Subject: UniStar Nuclear Energy, NRC Docket No. 52-016
Response to Request for Additional Information for the
Calvert Cliffs Nuclear Power Plant, Unit 3,
RAI No. 35, Turbine Area Ventilation System
RAI No. 87, Engineered Safety Feature (ESF) Ventilation System

**Response to NRC Request for Additional Information,
RAI No. 35, Question 09.04.04-1, Turbine Area Ventilation System, and
RAI No. 87, Question 09.04.05-1, Part A, ESF Ventilation System,
Calvert Cliffs Nuclear Power Plant, Unit 3**

Figure 9.4-2 - {Turbine Building Ventilation System}

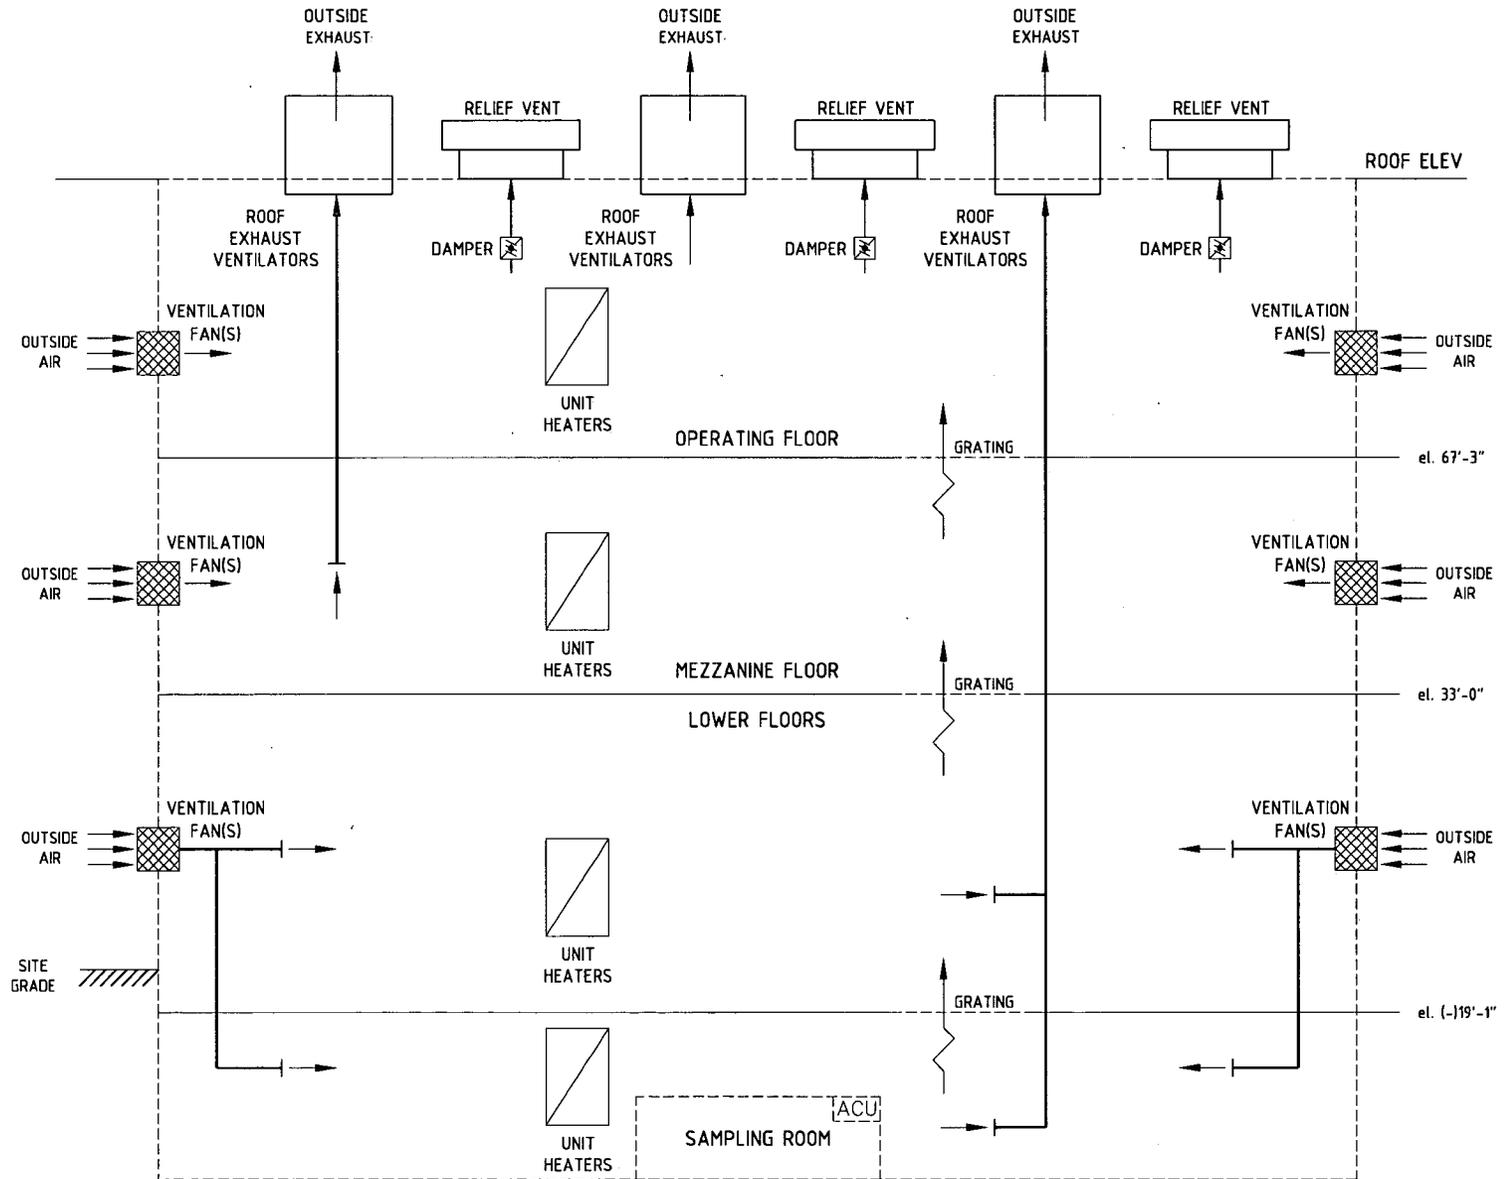
The applicant's FSAR does not provide design information on the Turbine Building Ventilation System. The FSAR references the U.S. EPR DCD with no departures or supplements. Section 9.4.4, "Turbine Building Ventilation System," consists of a paragraph which states that the turbine building is classified as non-safety related system. It does not provide information described in RG 1.206, Section C.I.9:

Please submit more specific information for the Turbine Building Ventilation System, as described in RG 1.206, Section C.I.9.4.4 guidance, or justify an alternative.

The Turbine Building Ventilation System is shown in Figure 9.4-2.

Outside air is supplied to the Turbine Building by fans via intake louvers and exhausted to the atmosphere by roof exhaust ventilators. During normal operation outside air is mixed with recirculated air to maintain a positive pressure in the Turbine Building.

The Turbine Building Ventilation System removes heat generated by equipment and from the environment to maintain acceptable indoor ambient conditions. Unit heaters are used to maintain the minimum room temperatures within the Turbine Building.
